# LAYTON TREE CONSULTING, LLC

## TREES & CONSTRUCTION MEMO

To: Matt Glaser, McCullough Architects  
From: Bob Layton  
CC: Bogdan Maksimchuk, Barcelo Homes  
Date: April 12, 2022  
Re: Tree Protection at 7216 93<sup>rd</sup> Ave SE – Tree #18

Tree #18 Diagram

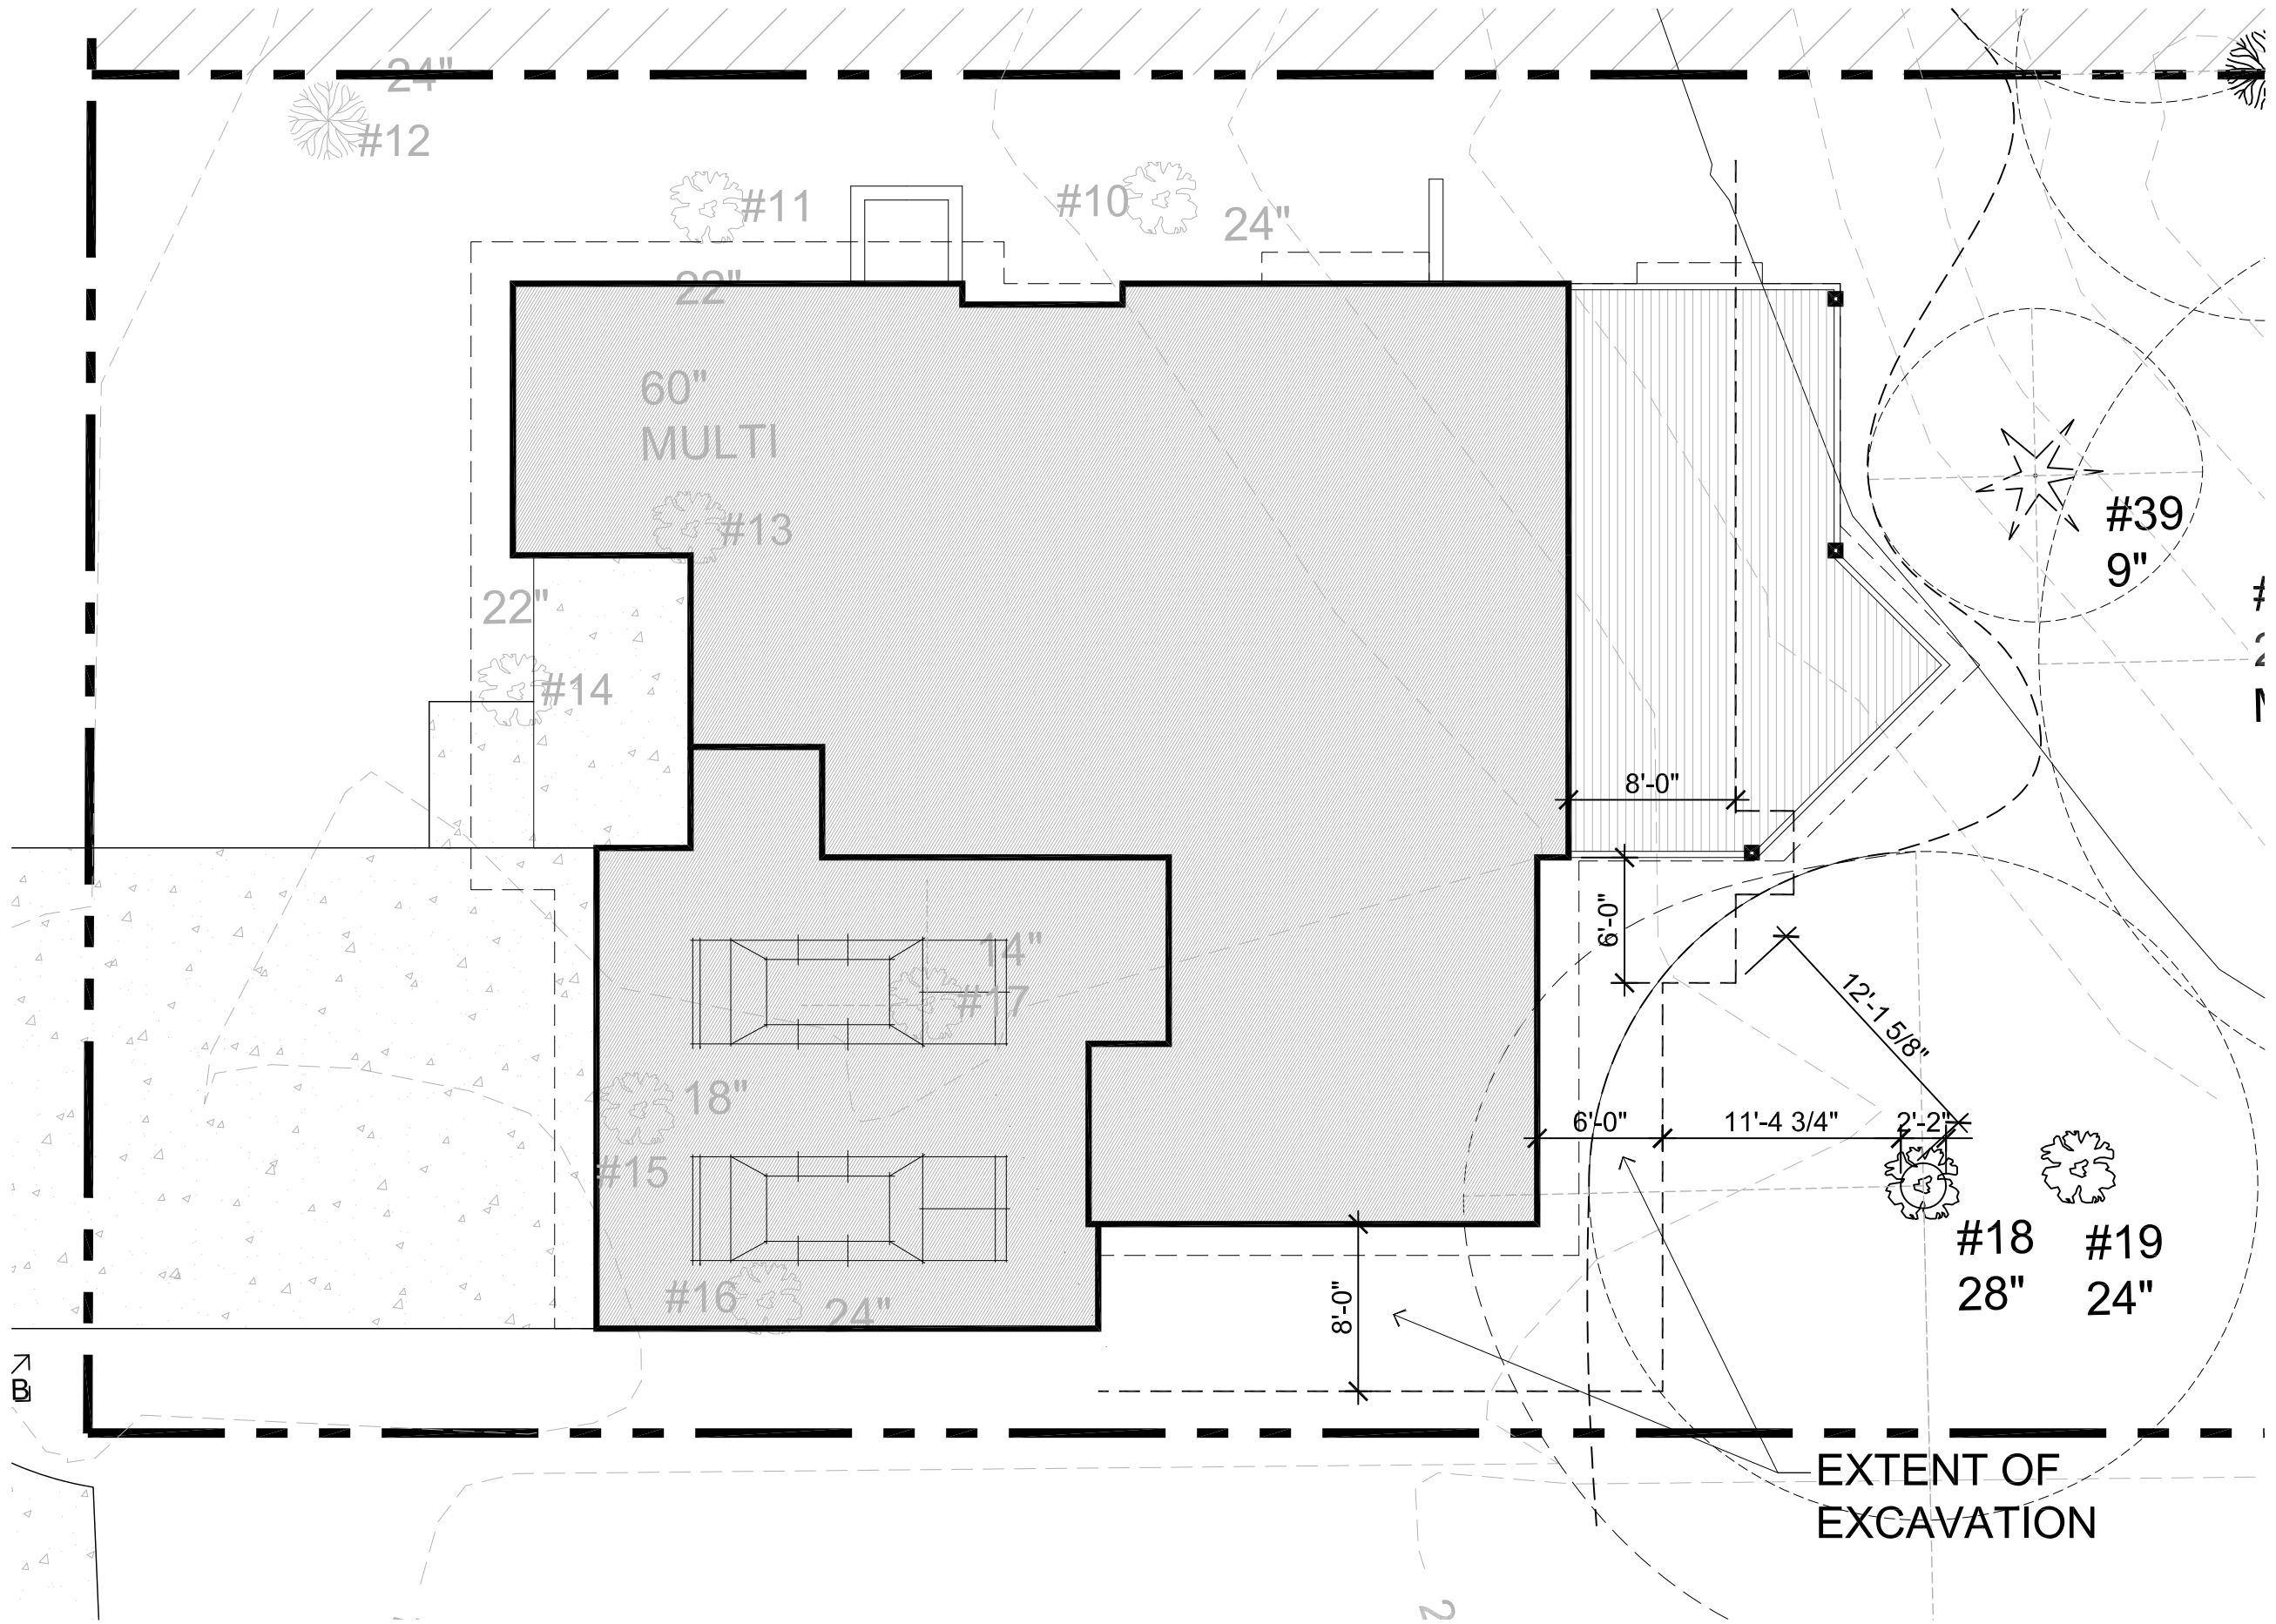
Cutting the roots at this location is not recommended. Long-term tree health is likely to be jeopardized. I would be comfortable allowing an 11-foot Limit of Disturbance from the trunk face as shown on the attached diagram. The roots at this distance would be notably smaller than those exposed at 8-feet from the trunk face. I would not expect any consequential impacts on the long-term health or stability of the tree so long as work is carried out diligently and the tree protection recommendations and guidelines as outlined in the arborist report and below are adhered to. This would also afford 6-feet of clearance between the tree protection zone and the new building at the closest distance to the tree.

Bigleaf maple is a hardy species and tolerable of the proposed impacts, so long as work is carried out diligently. Protecting the soils within areas that do not need to be disturbed will be important to reduce the overall impacts and stress on the tree. Cover all of these areas with a protective covering of a +/- 6-inch layer of coarse wood chip mulch or hog fuel.

All severed or damaged roots at the excavation limits outside of tree protection areas will be hand-excavated and pruned back to healthy, sound tissue, prior to backfilling or finishing areas. Sound tissue is where the root is undamaged and the bark is completely intact with the root.
